COUNCIL ASSESSMENT REPORT

Panel Reference	PPSSNH-452
DA Number	LDA2023/0323
LGA	City of Ryde
Proposed Development	Construction of a mixed-use development comprising three residential flat buildings containing 194 apartments, a centre-based childcare facility, basement car parking, stormwater management works and landscape works
Street Address	691 to 695 Victoria Road, Ryde
Applicant	Chanine Design Pty Limited
Owner	AMHA Properties Pty Limited
Disclosures	No disclosures with respect to the <i>Local Government and Planning Legislation Amendment (Political Donations) Act 2008</i> have been made by any persons.
Date of DA lodgement	15 December 2023
Total number of unique Submissions	12 unique submissions received
Recommendation	Refusal
Regional Development Criteria SEPP (Planning Systems) 2021	<ul style="list-style-type: none"> • General development over \$30 million. • Development that is subject to 10 or more unique submissions by way of objection. • Development that contravenes a development standard by more than 10%.

Figure 13 – Site layout.

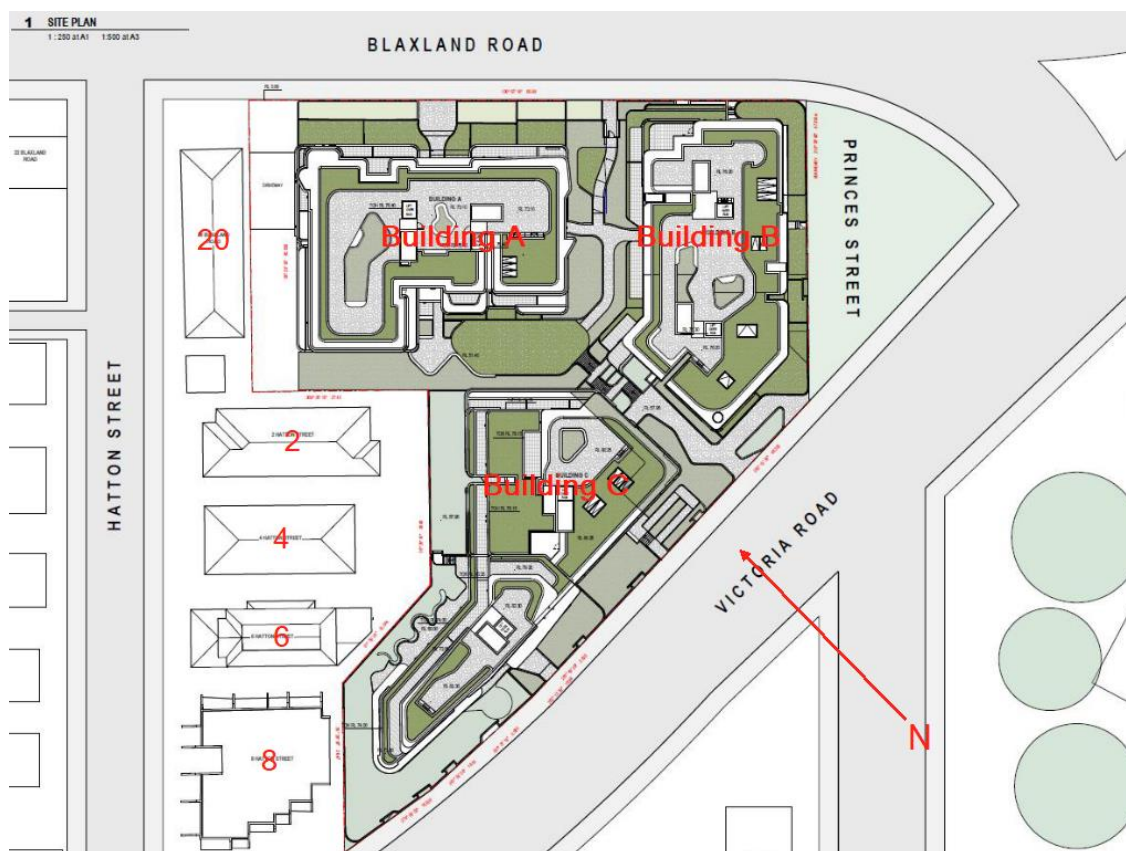
The arrangement of the buildings on the site does not create pleasant or well-proportioned spaces between the buildings that provide useful communal areas.

Figure 17 – Location of the proposed vehicle accessway.

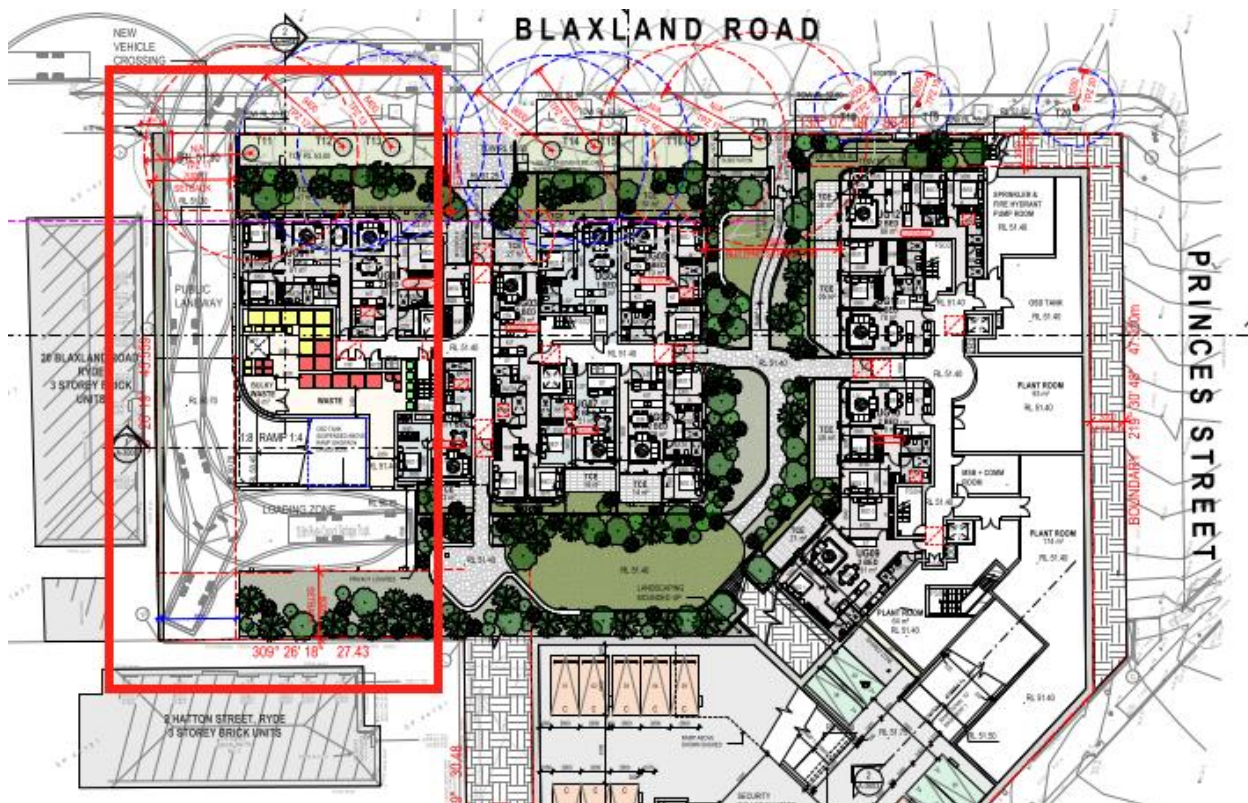
The development proposes a vehicle accessway at the north-western side of the site as shown marked up in red in **Figure 17** below.

As shown below, the proposed vehicle accessway terminates at the south-western (rear) boundary and provides sole vehicle access to the basement car park and loading dock. The vehicle accessway does not provide any separate pedestrian access nor facilitate any activation along the accessway. In this respect, the vehicle accessway is described as a private driveway only and not a public laneway.

With respect to the provision of a public laneway; Clause 8.3.1 Future Character of Part 4.4 of the Ryde Development Control Plan 2014 does not require this site to accommodate a laneway.

Therefore, as the driveway is not considered to be a public laneway the development cannot benefit from the incentive provisions of Clauses 4.3A and 4.4A and the development standards contained under Clauses 4.3 and 4.4 apply.
